## **Amendment Report**

**Licence Number** L9329/2022/1

**Licence Holder** Penny Operations Pty Ltd

**Premises** Penny Gold Project

Figure 1: Penny West landfill within the WRD.

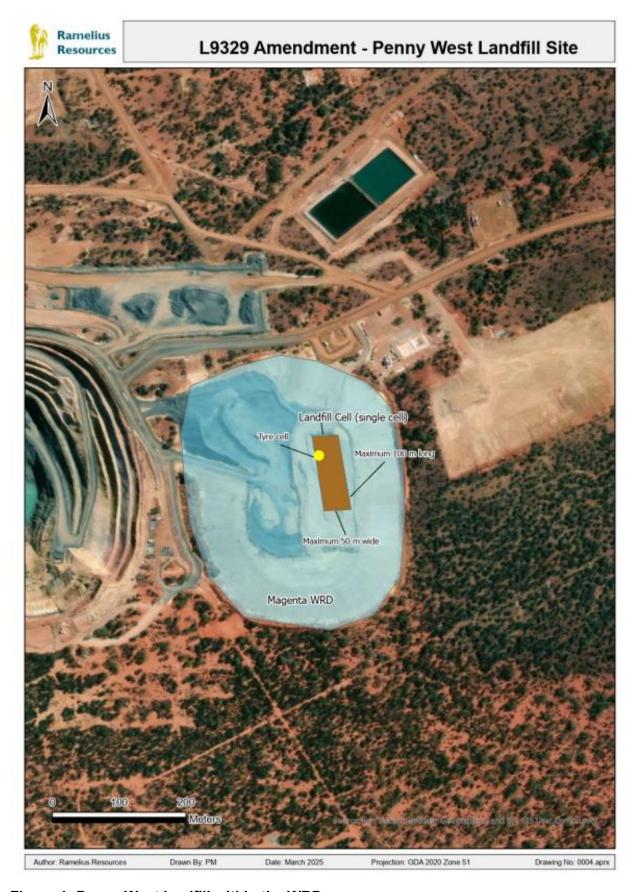
The landfill design will include a sequenced construction of a series of trenches and will not exceed 5 m deep, 50 m wide and 100 m long (as specified in Figure 1). There will be one active cell open at a time and will be backfilled before a new one is prepared in the same location. The primary construction materials will include calcrete, mottled clay and saprolite material.

Used tyre disposal/storage will only be accepted within the specified tyre disposal cell in the Penny West landfill (as shown in Figure 1). No more than 99 tyres will be stored within the Penny West landfill at any one time, therefore Category 57: Used tyre storage will not be required to be added to the licence. The disposal of the tyres will be regulated under inert waste type 2 in the existing Category 64 on licence L9329/2022/1.
